Technical Bulletin SWEM20-001-TB

Subject:How to replace OLED in ICP panel

SWEM20-001-TB

KY-692 A Side

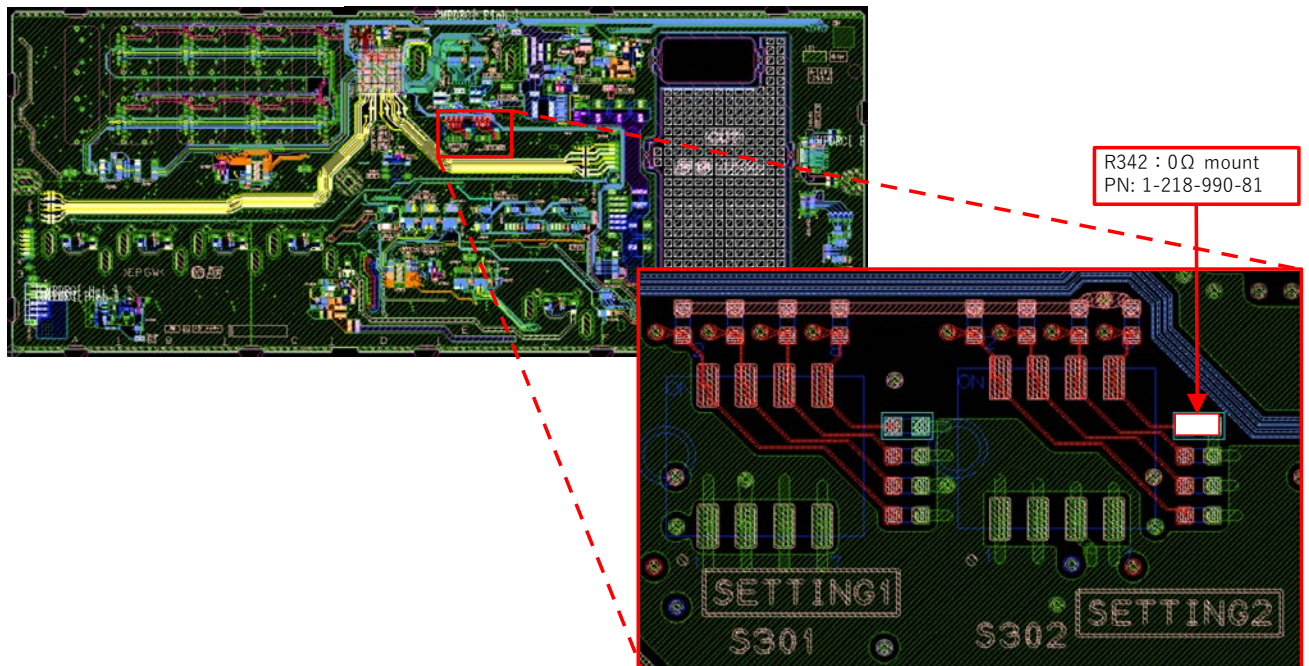
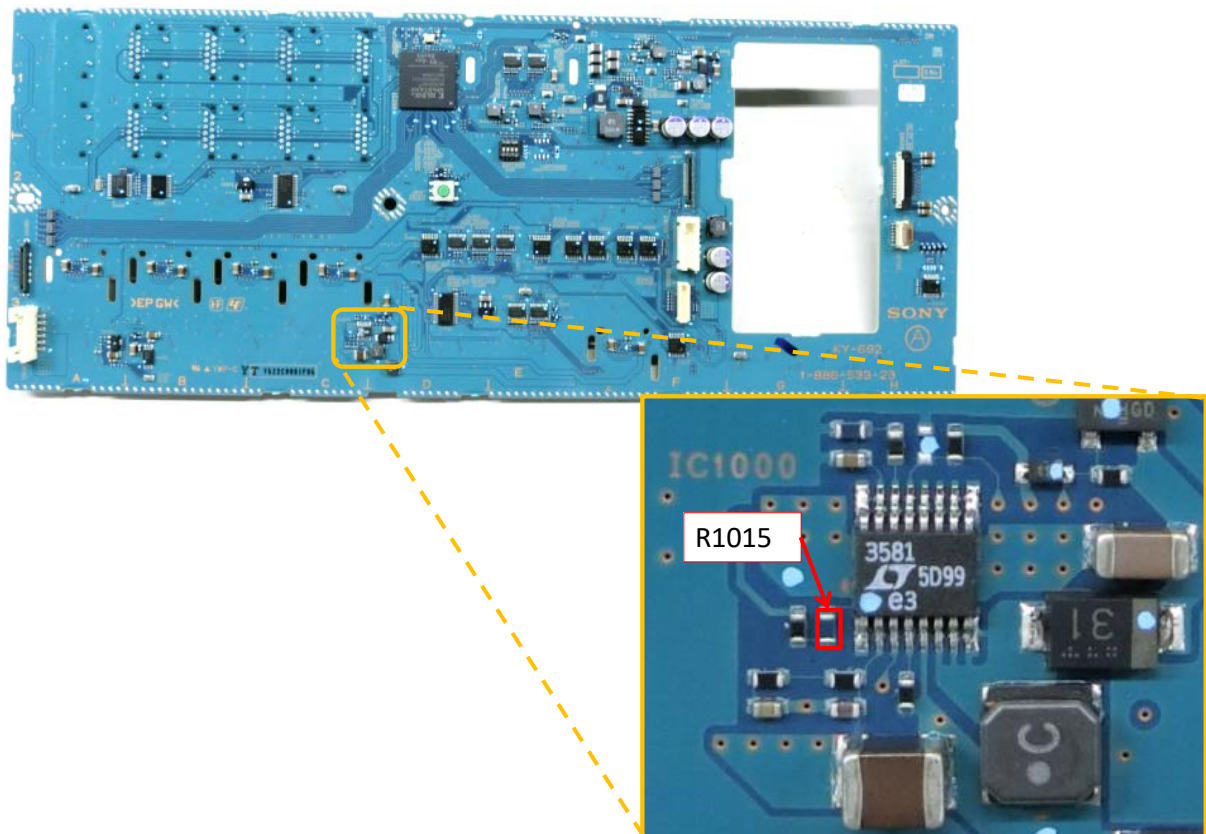
For area S: KY-692

- Mount a 0Ω resistor on R342. (Set FPGA to new 0.8-inch OLED mode.)

- Remove R1015 and mount a $30k\Omega$ resistor instead. ($10.4V \Rightarrow 12.0V$)

KY-693 A Side

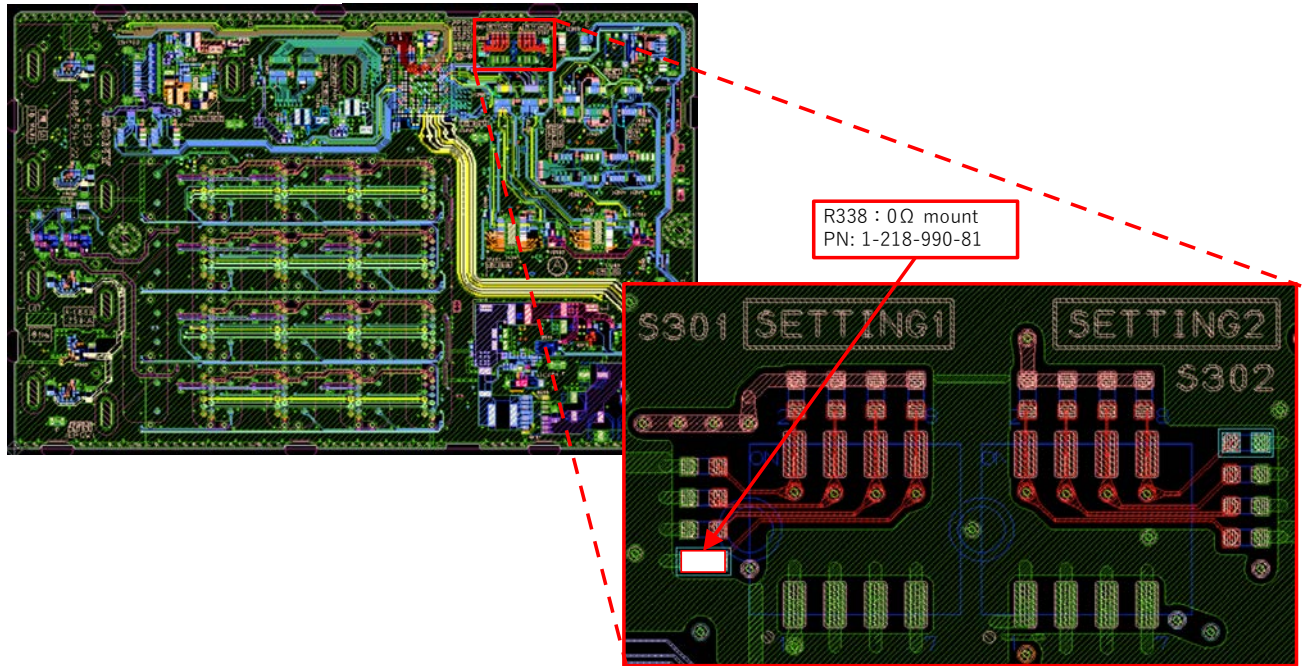
For area T: KY-693

- Mount a 0Ω resistor on R338. (Set FPGA to new 2.7-inch OLED mode.)

KY-693 A Side

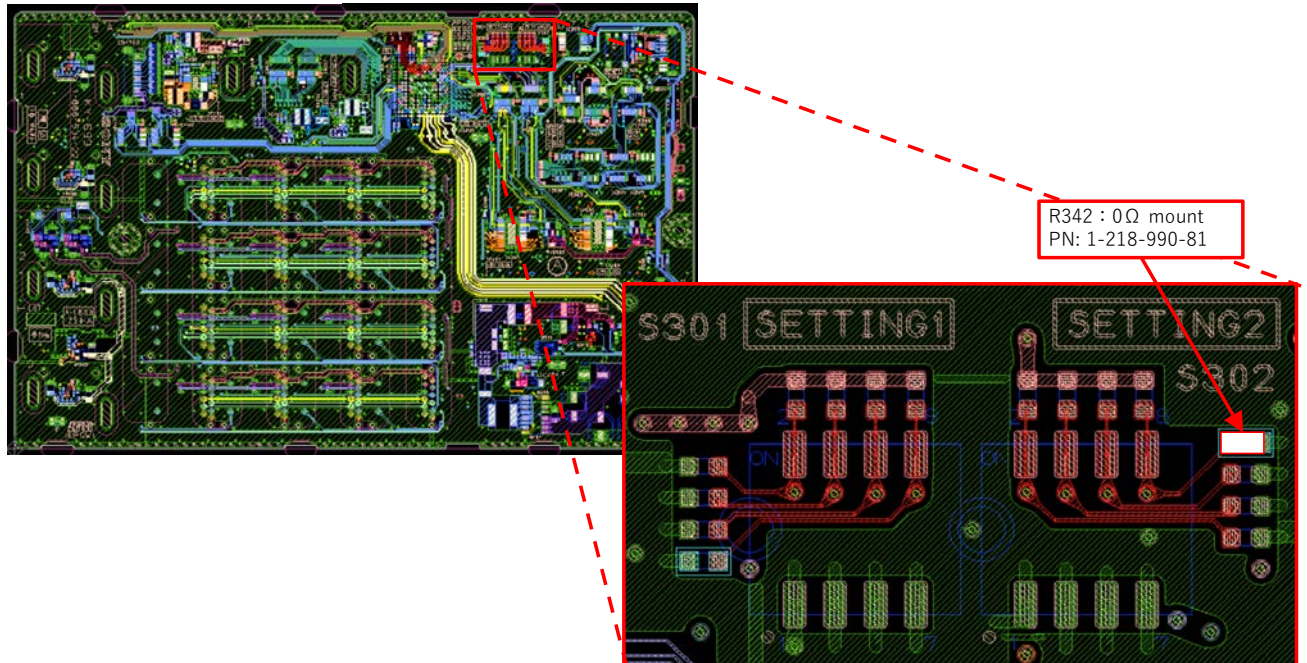
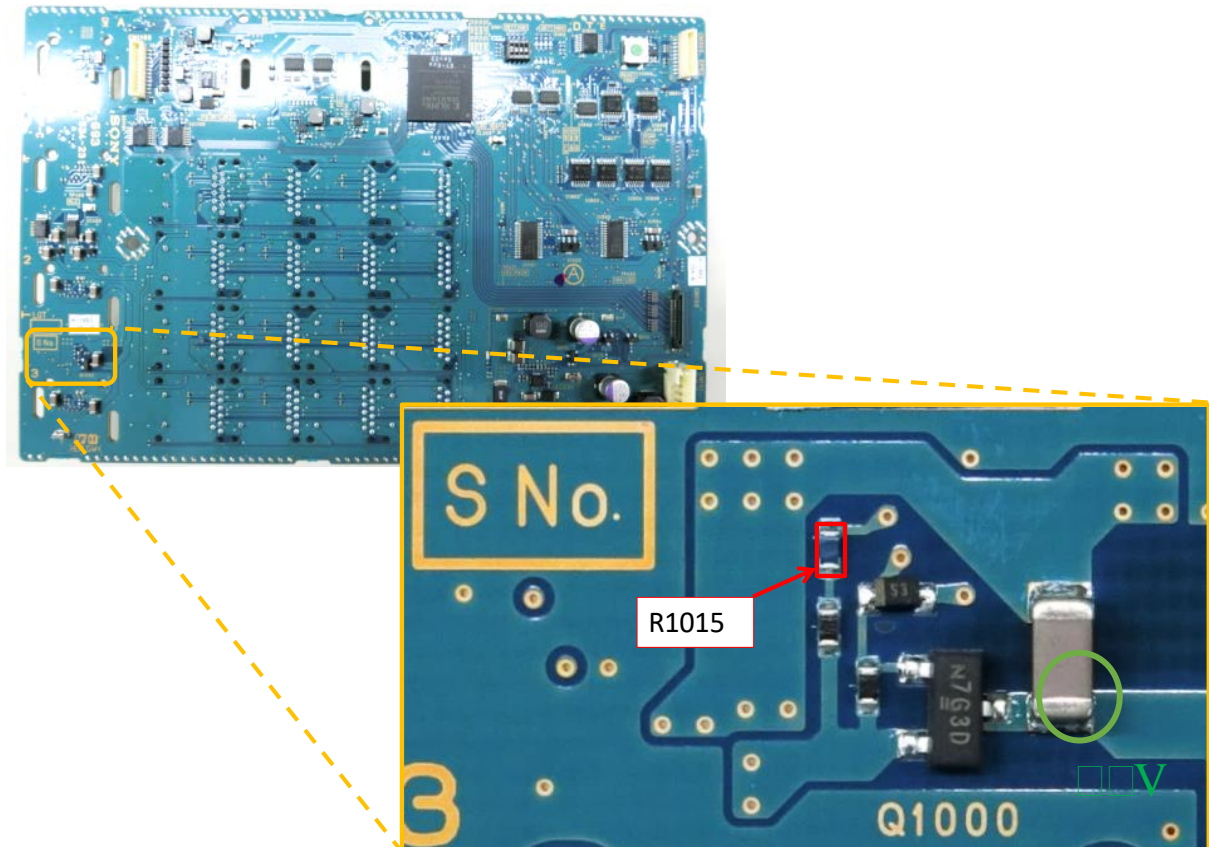
For area U: KY-693

- Mount a 0Ω resistor on R342. (Set FPGA to new 0.8-inch OLED mode.)

- Remove R1015 and mount a 30kΩ resistor instead. (10.4V⇒12.0V)

*If the repair is done correctly, the green part shows a voltage of 12V.

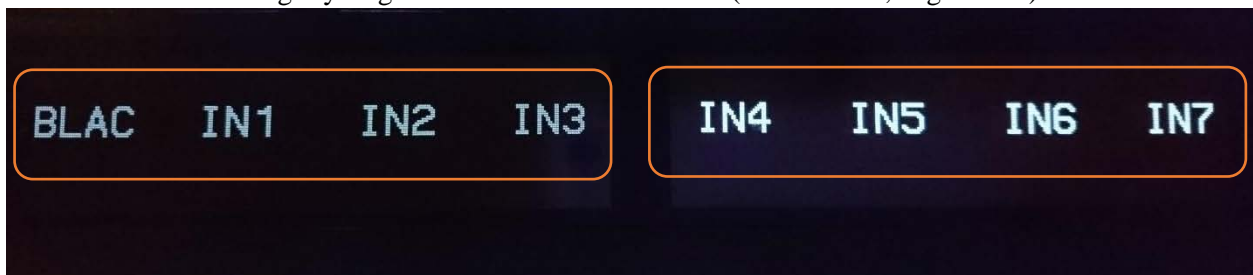
If the FPGA is the former version or the 0Ω resistor is not mounted correctly, the following symptoms will occur:

The display is shifted one dot to the left or right and line-like noise appears at the end.

Looks slightly brighter than conventional ones. (Left: former, Right: new)

New and former 2.7-inch OLED

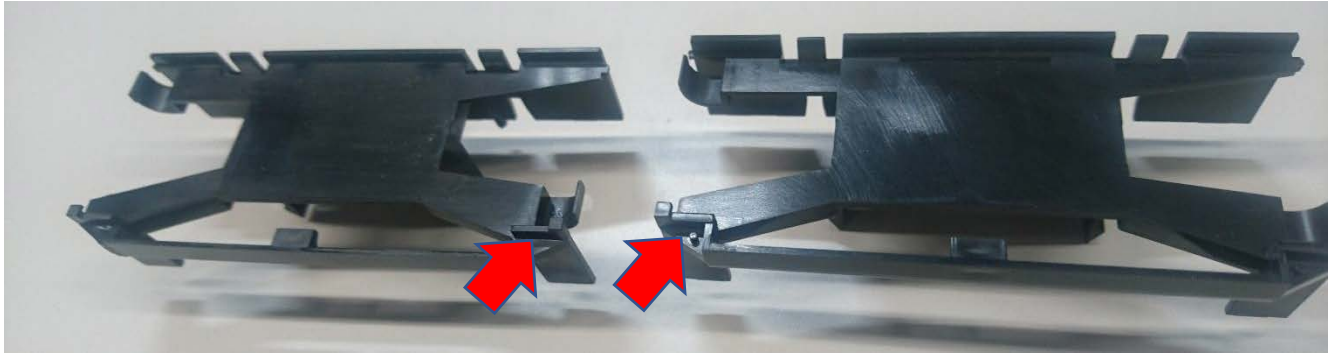
Left: former OLED / Right: new OLED

New and former 2.7-inch holder

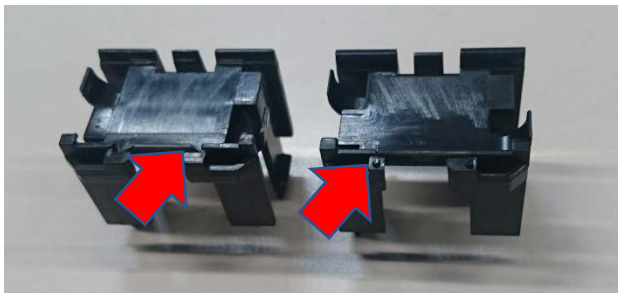
Left: Former 2.7-inch holder / Right: New 2.7-inch holder
